# FACPAC PO Change Order Supplemental Information Form (Ref# 57586)

Tier 1 Project: Phase 6 Additions and Renovations - Project #175-520

**CHANGE ORDER NUMBER:** 215-04-01  
**INITIATION DATE:** 3/7/2023

007 - Contractor Claim 007 Add Duct Sock per RFI#60 Response

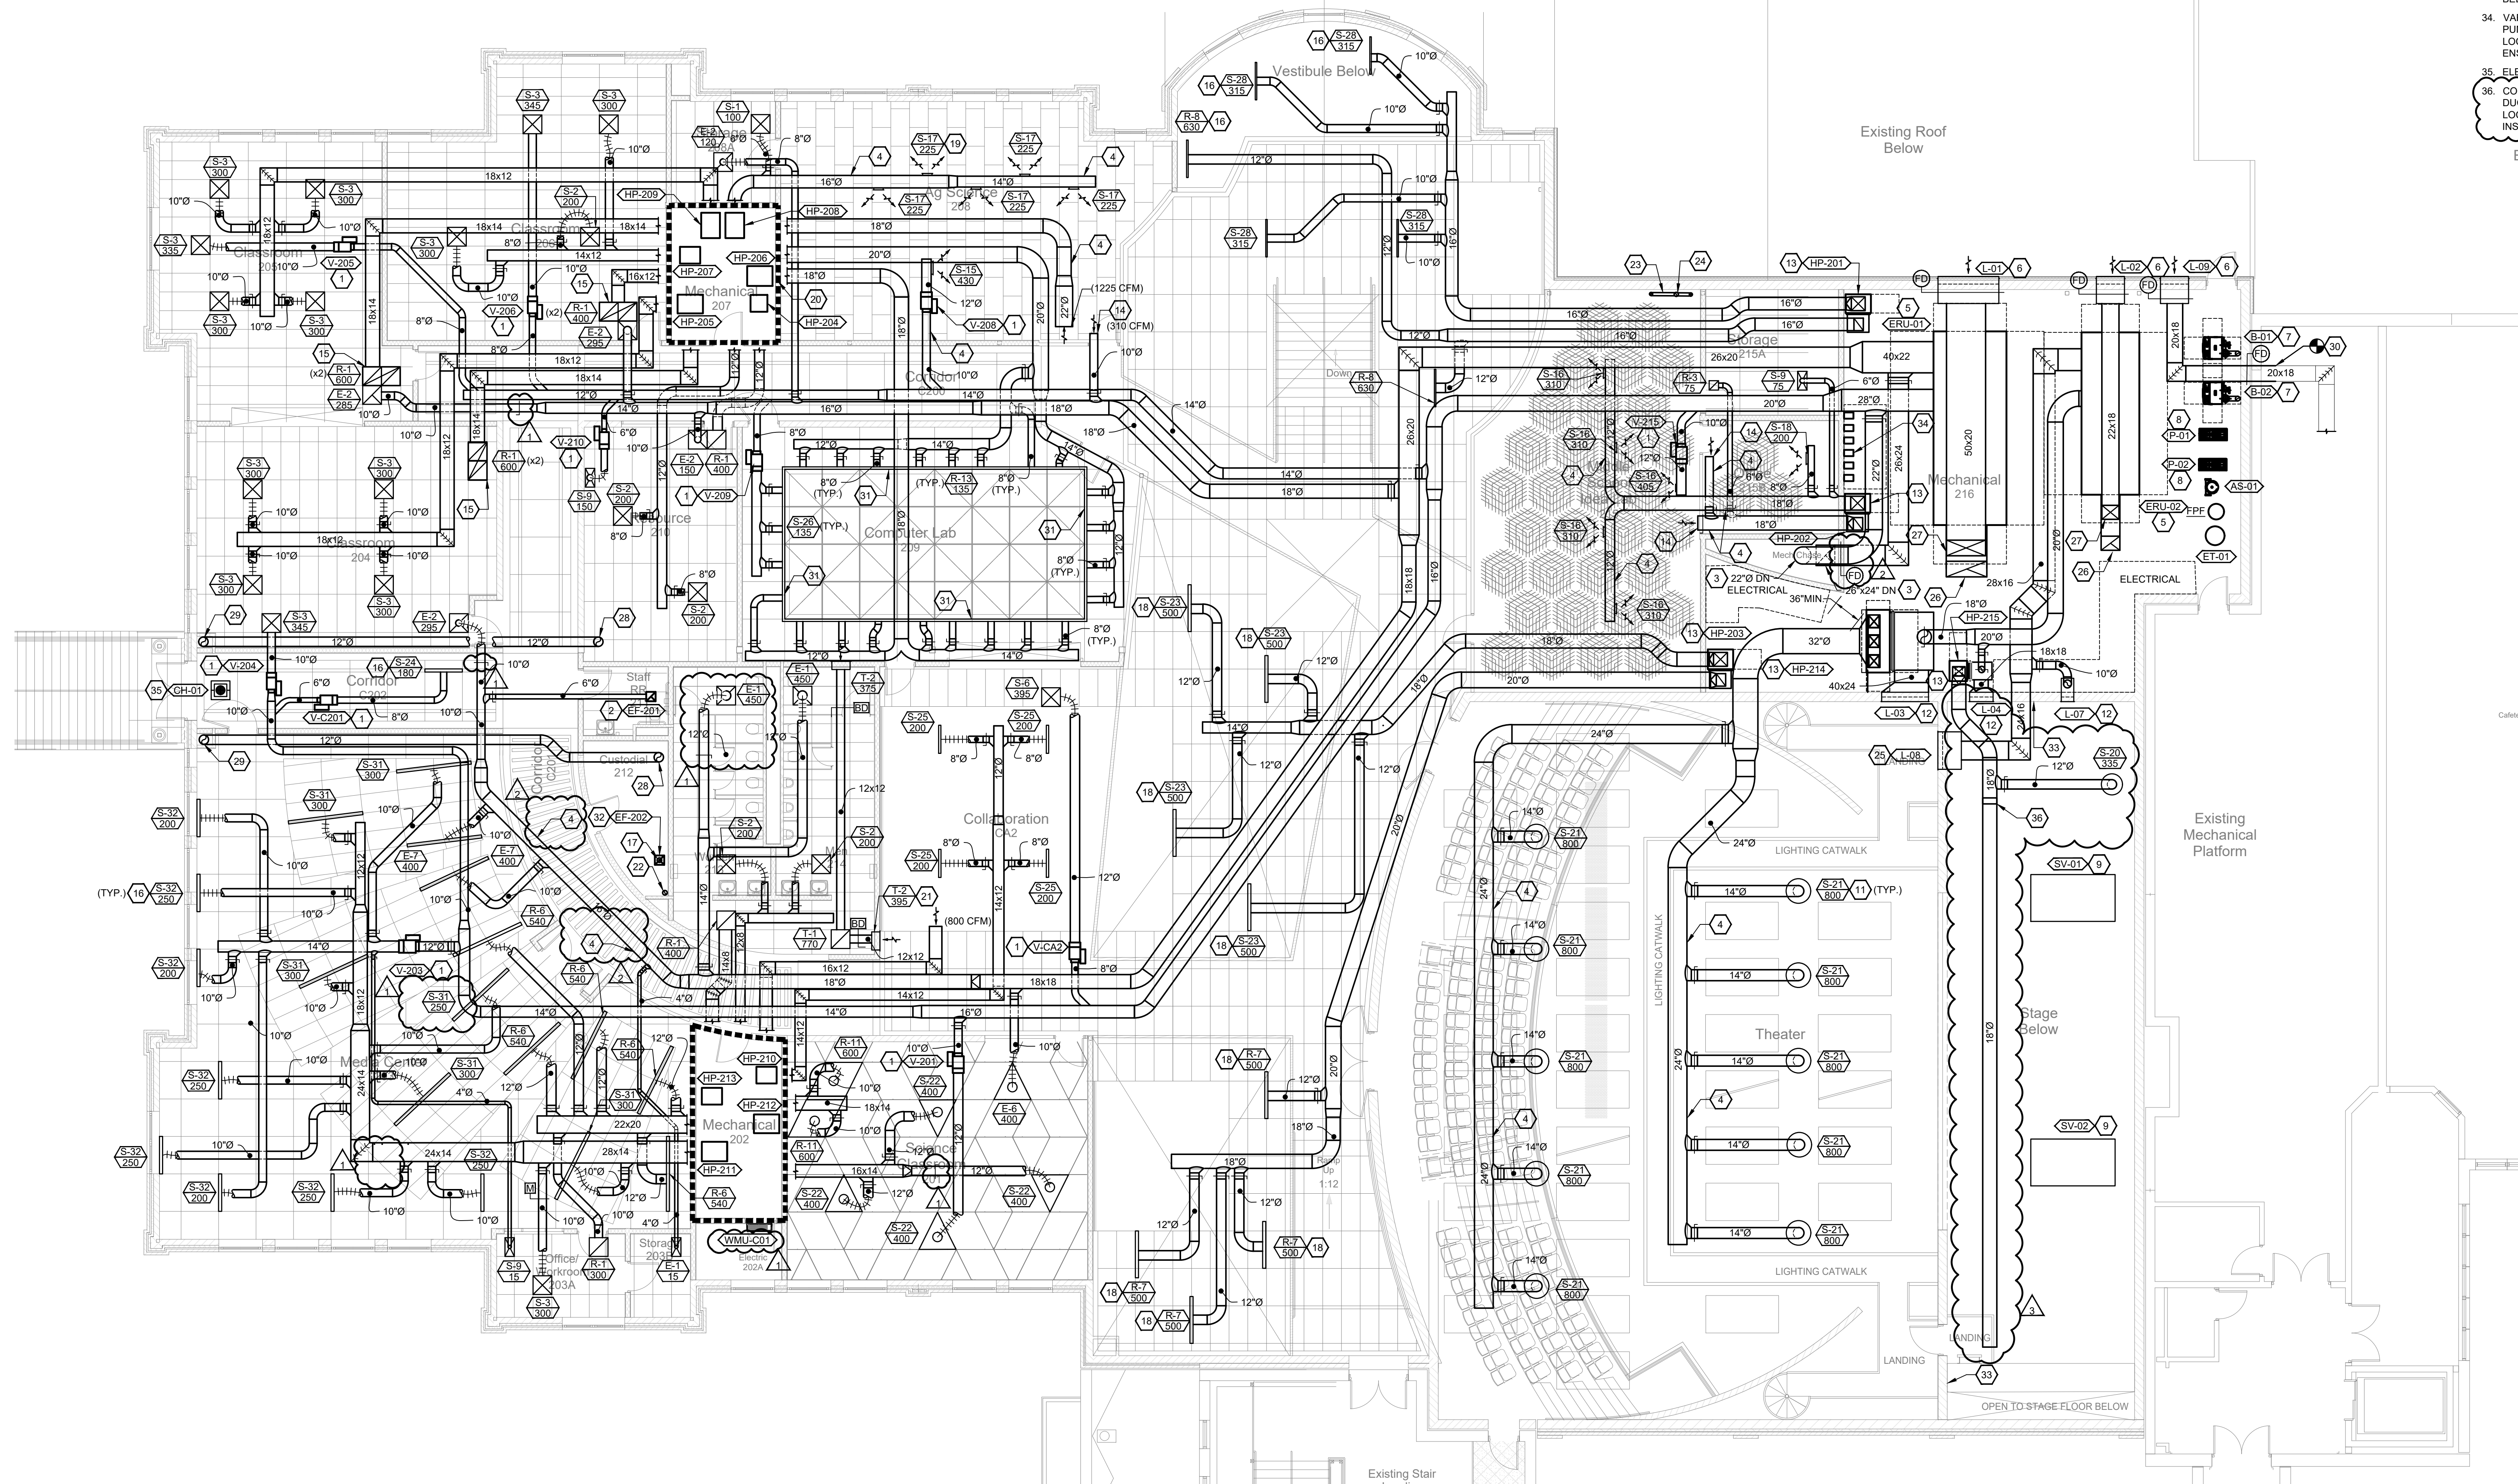
Please review attached marked up contract drawings TH101 and M104.

Ductwork as shown on M104 in the Stage area will interfere with the Stage Rigging. Please refer to attached TH101 for more specific information.

Fire Sprinkler lines and electrical must also be carefully coordinated in the stage area.

18" Ø duct with diffusers across the stage shall be deleted and replaced with 18"Ø DuctSox.  
Attached are coordination drawings with Theater Rigging and HVAC.

**1 PARTIAL SECOND LEVEL - HVAC**  
SCALE: 1/8"=1'-0"

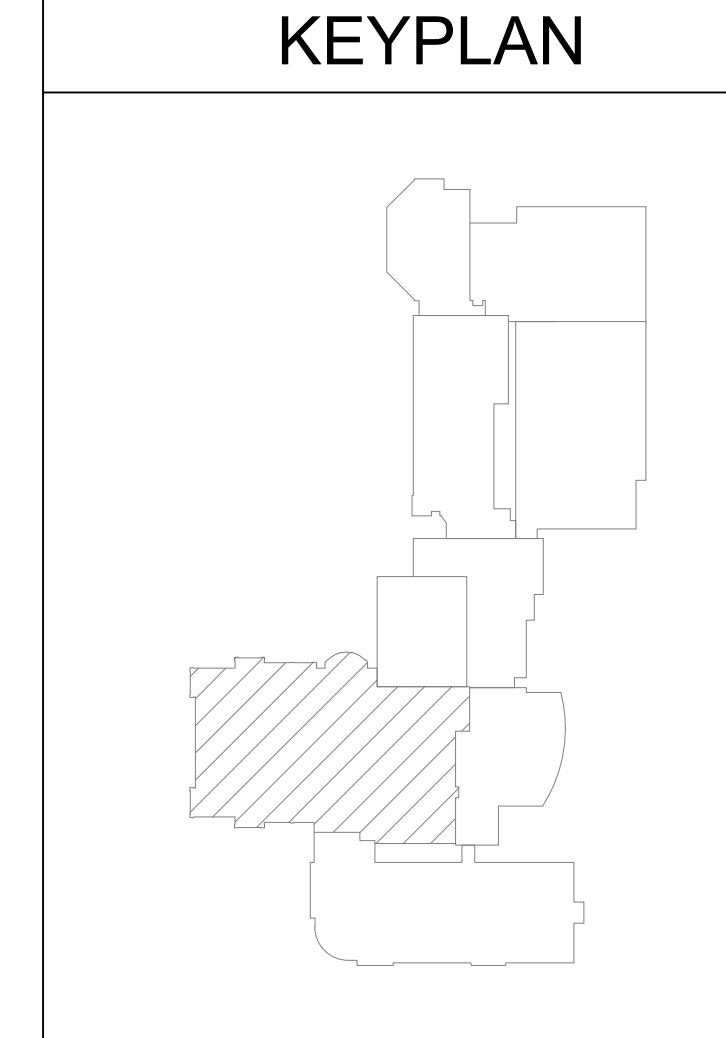
Delete Lineset #4  
General Purpose  
Lineset

Delete this General  
Purpose Lineset

Ductwork crossing the  
stage (must be above  
35'-0" AFF to bottom)

35. ELECTRIC CEILING HEATER.
36. CONNECT NEW 18"Ø DUCTSOX TO END OF DUCTWORK. DUCTSOX SHALL BE HELD AT 35" AFF. COORDINATE LOCATION WITH THEATER RIGGING PRIOR TO INSTALLATION.
